CITY OF ALBUQUERQUE

Re: Precision Eye Center 7521 Alameda Blvd. NE Traffic Circulation Layout Engineer's Stamp 02-13-23 (C19-D070)

Based upon the information provided in your submittal received 03-16-23, the above referenced plan cannot be approved for Building Permit until the following comments are addressed:

GENERAL NOTES 1. THESE DETAILS ARE PROVIDED FOR HIGH TRAFFIC

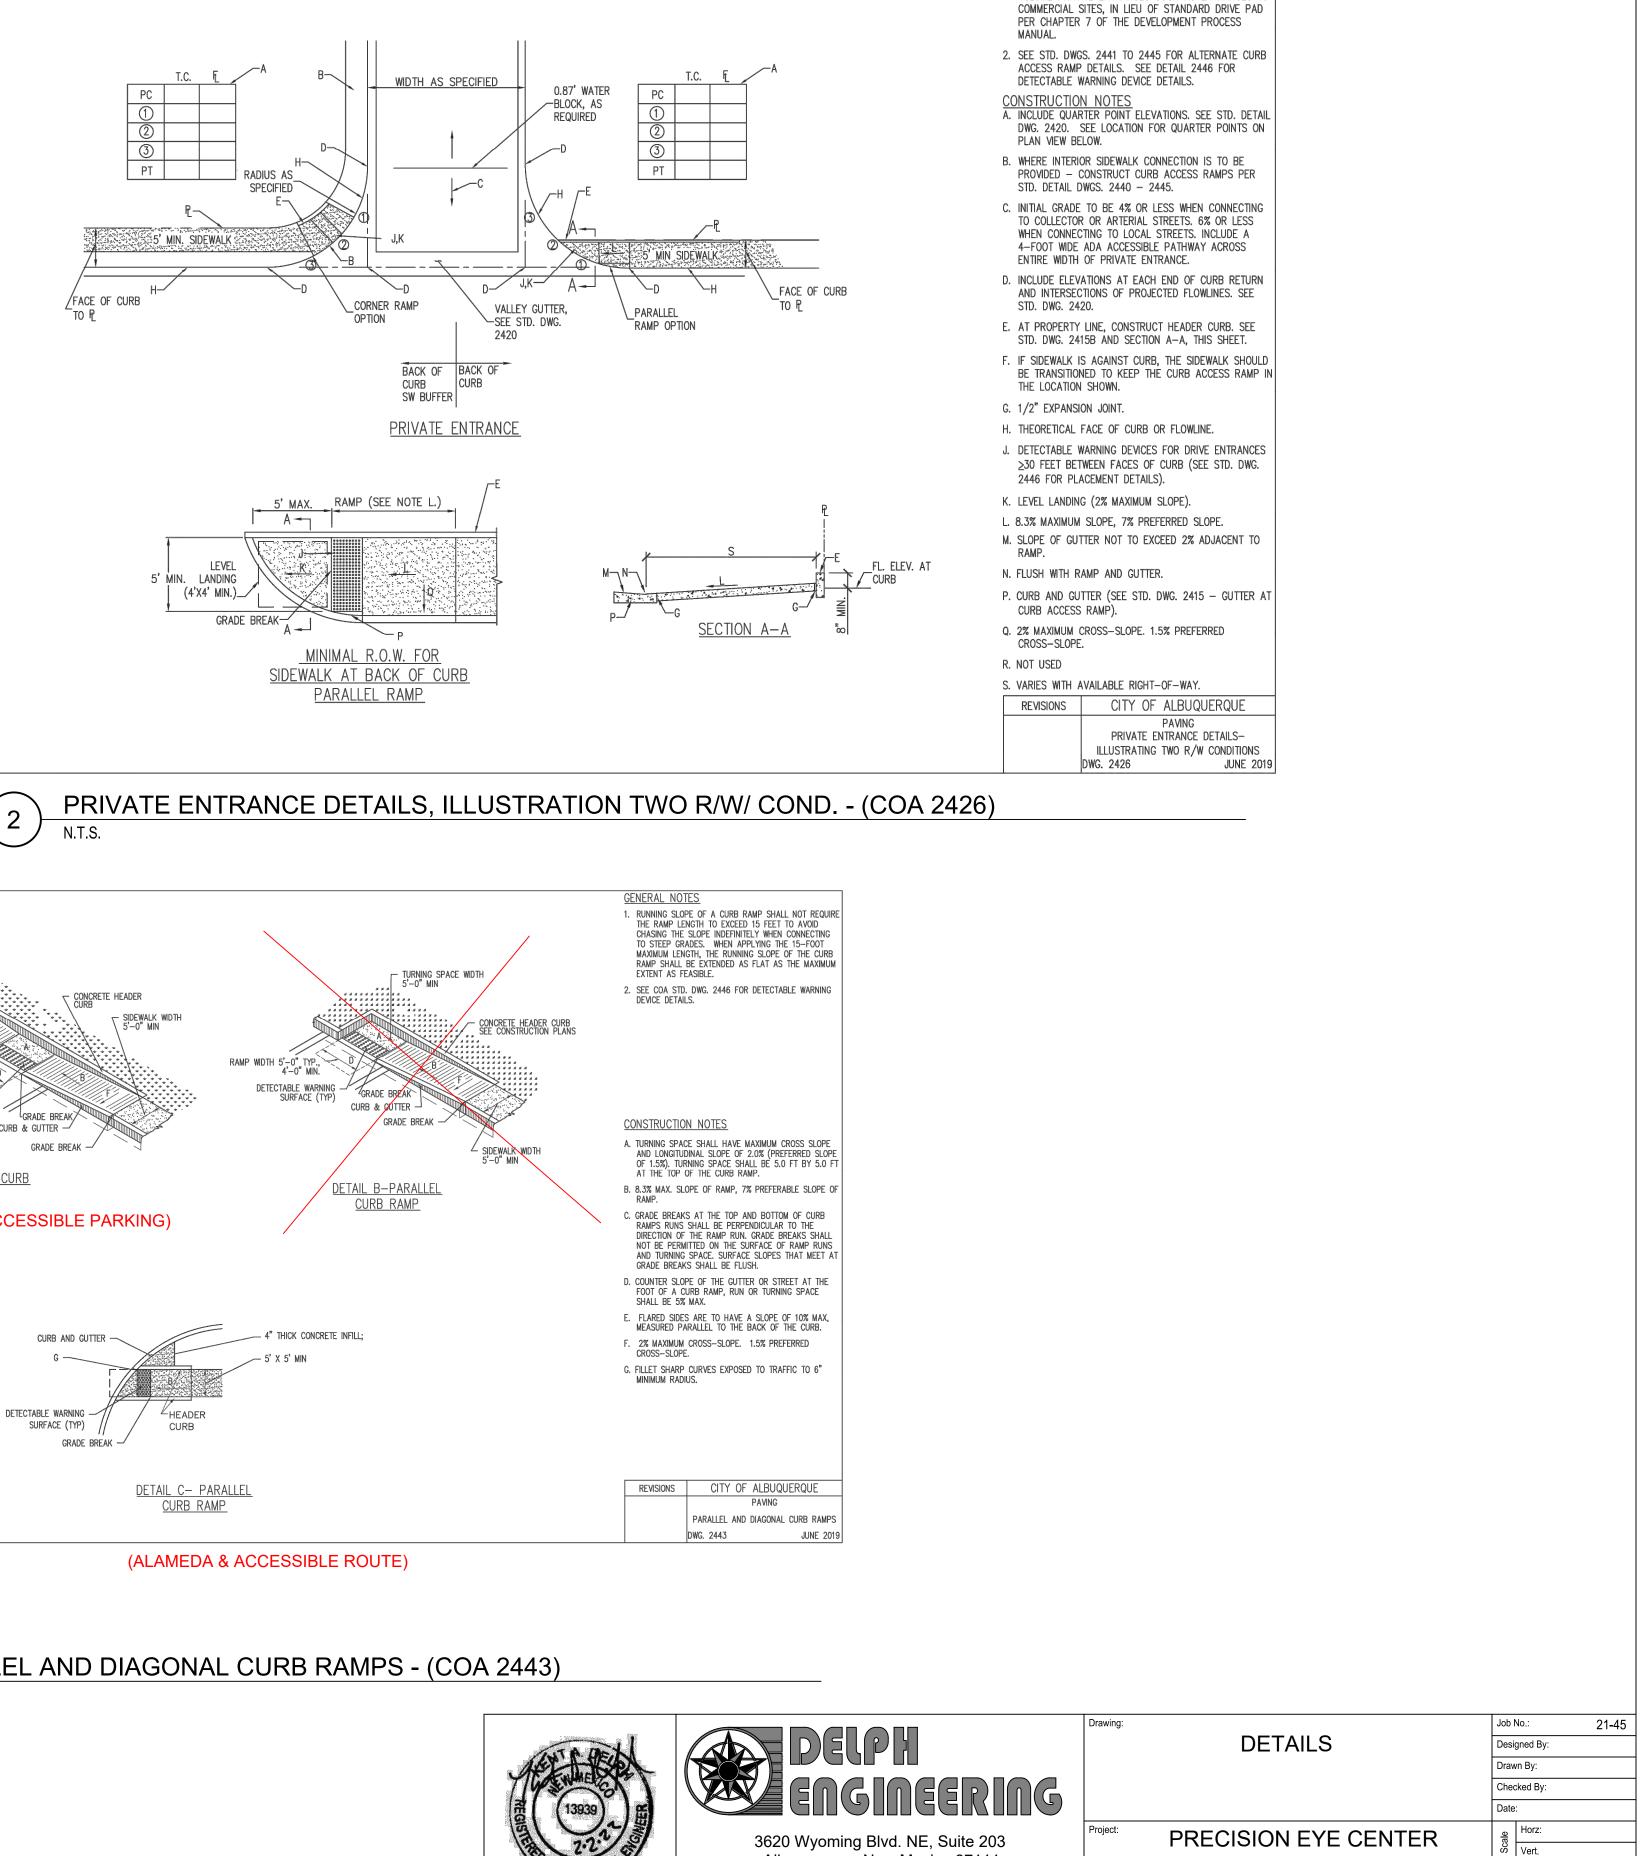
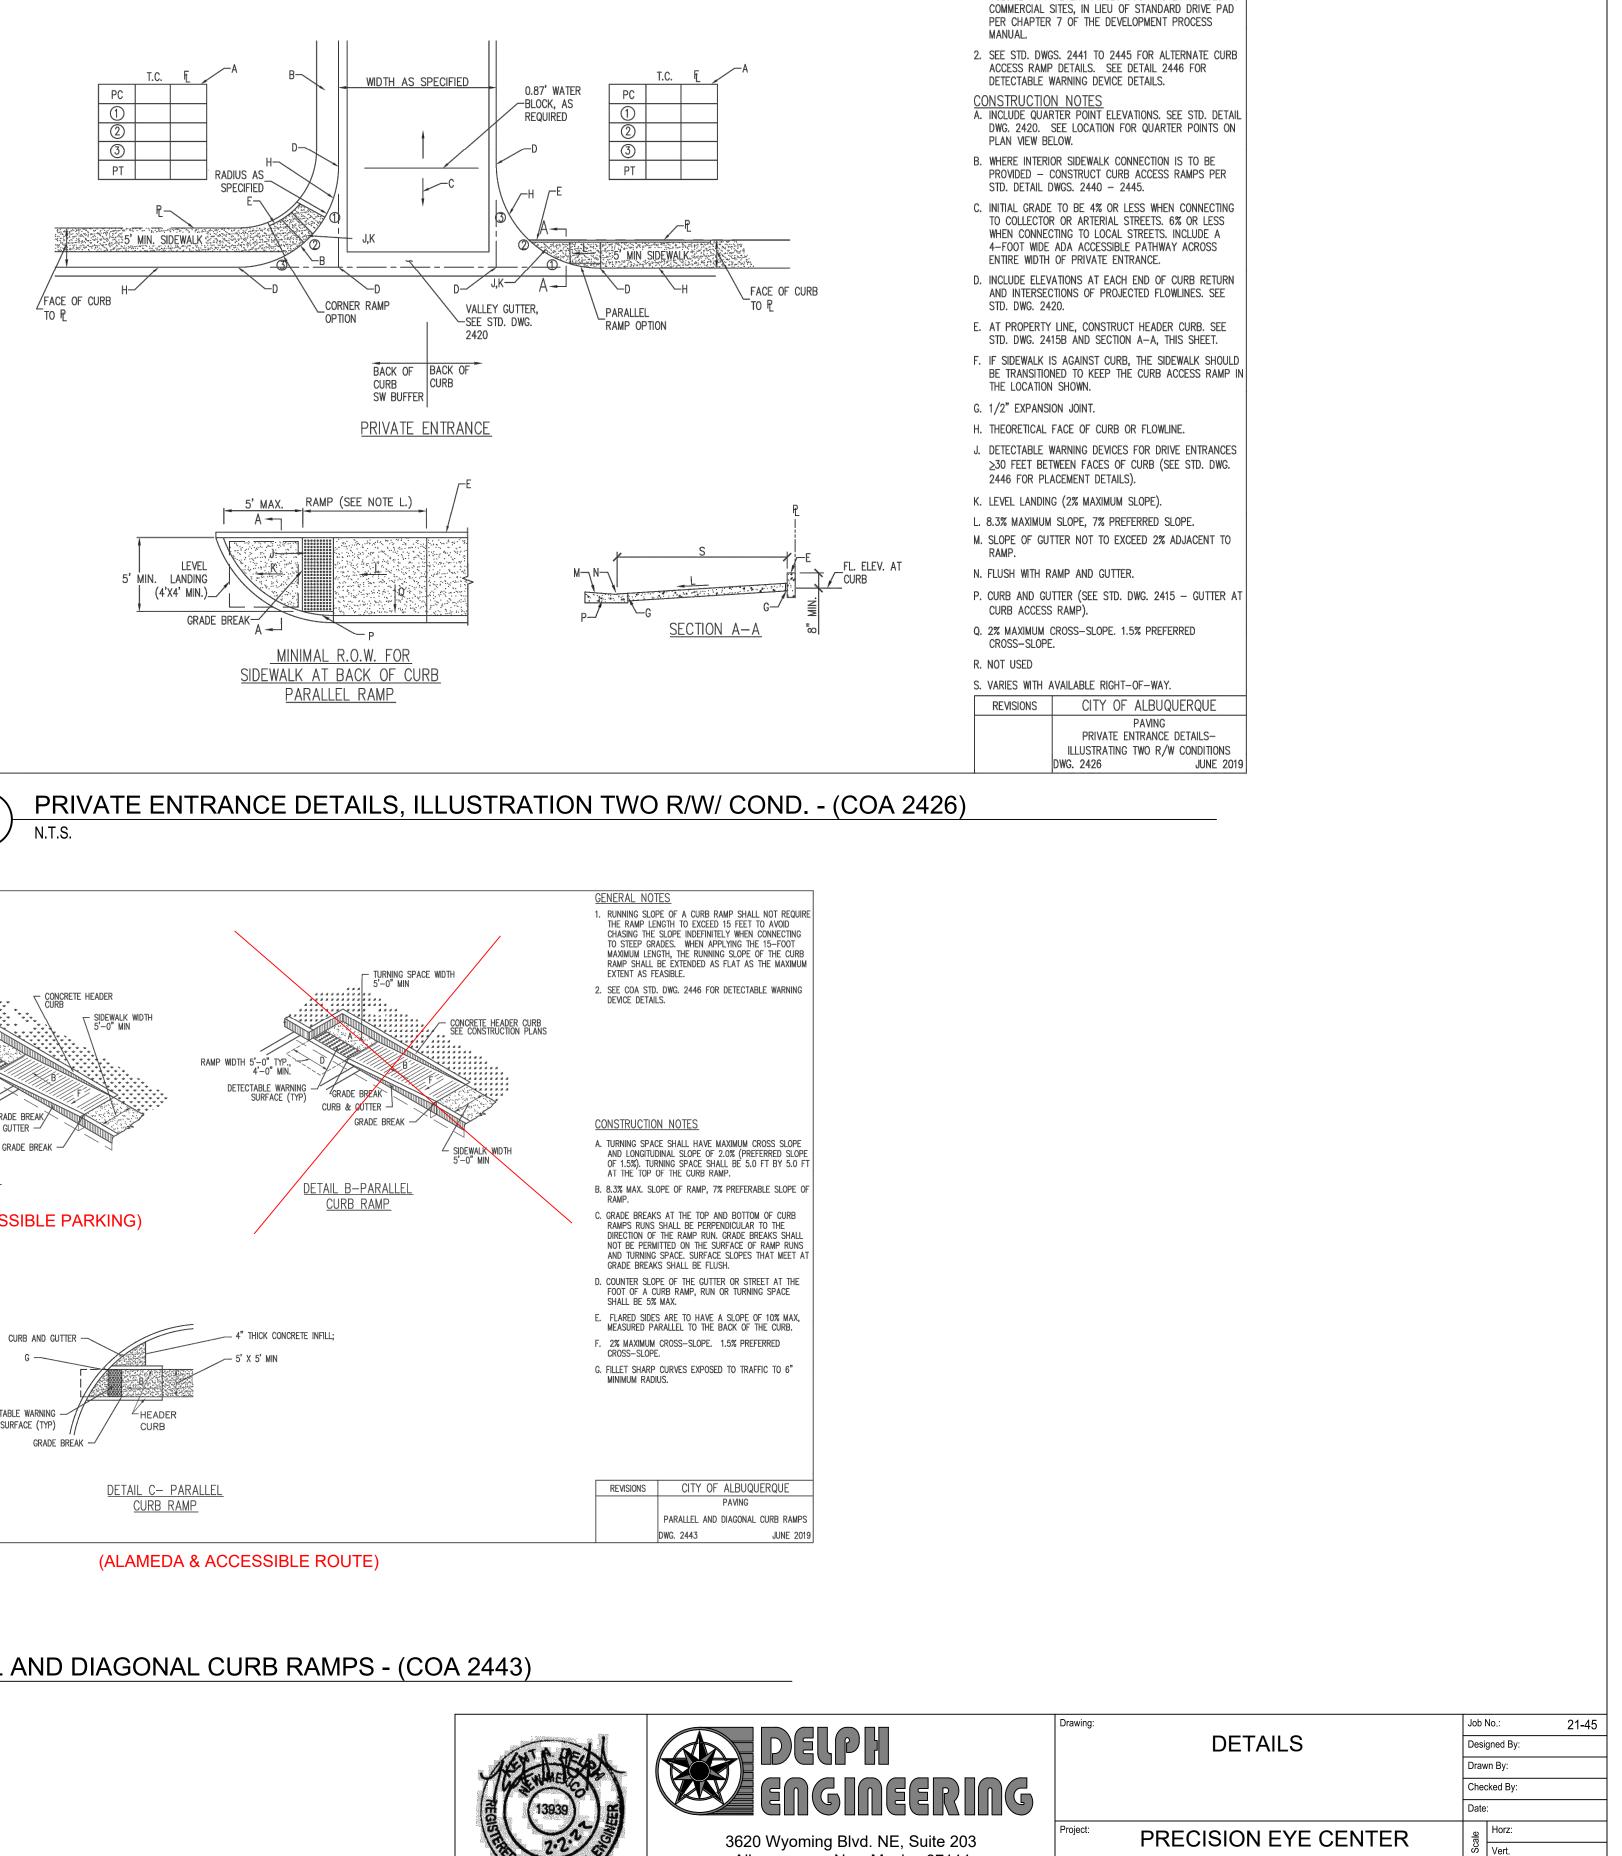
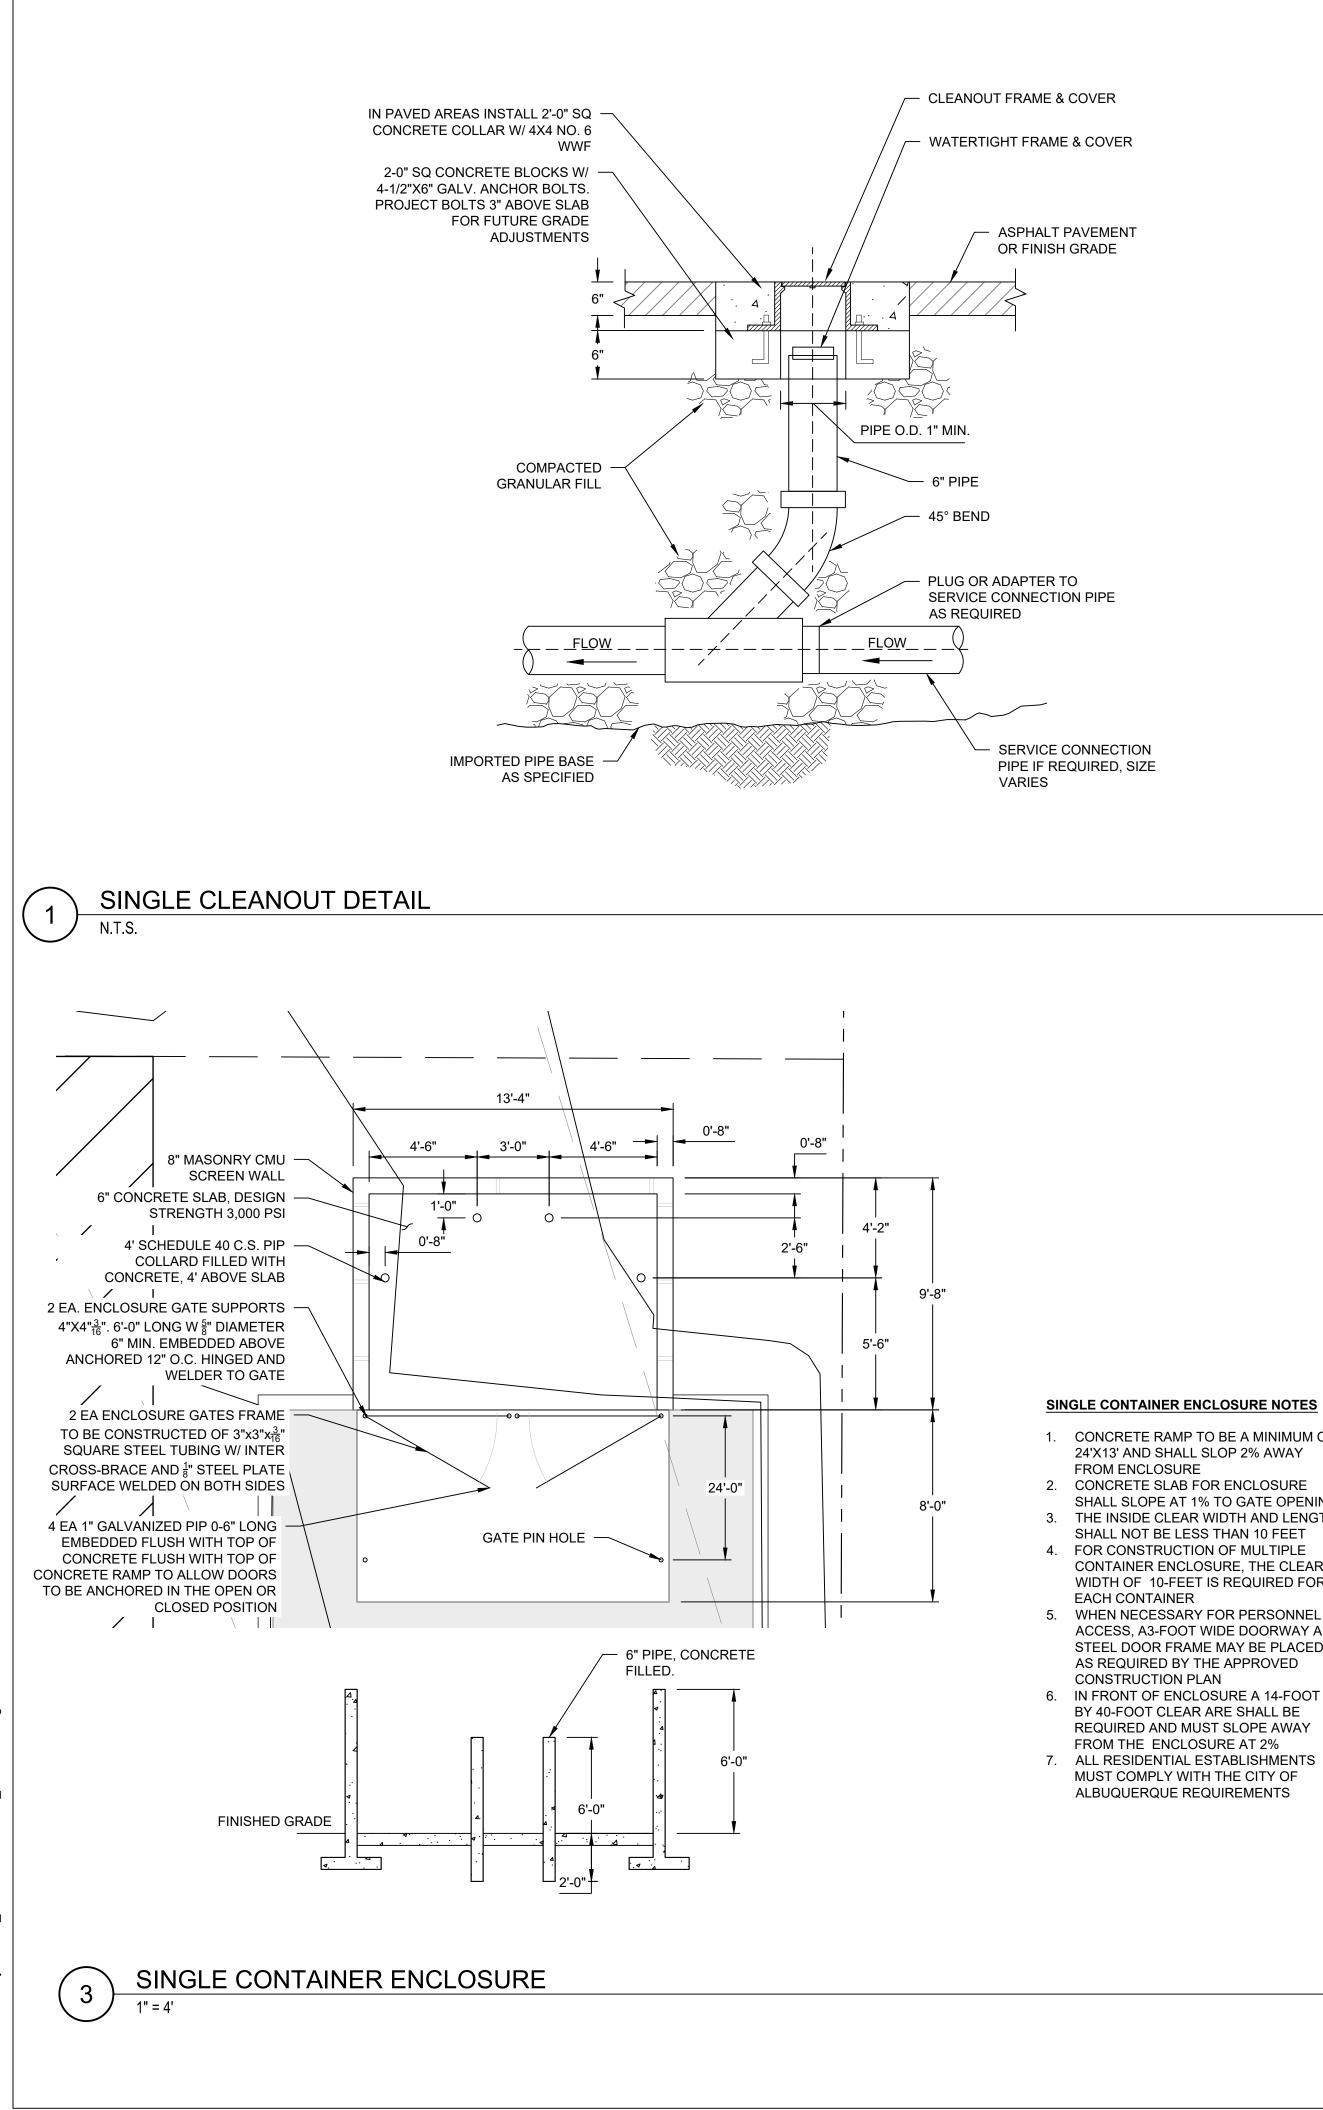
- 4. A 5 ft. keyway is required for dead-end parking aisles.
- 5. Please remove Plumbing details from Transportation details' sheet D-101.
 - 6. Refuse vehicle maneuvering shall be contained on-site. The refuse vehicle shall not back into the public right of way.; provide a copy of refuse approval.
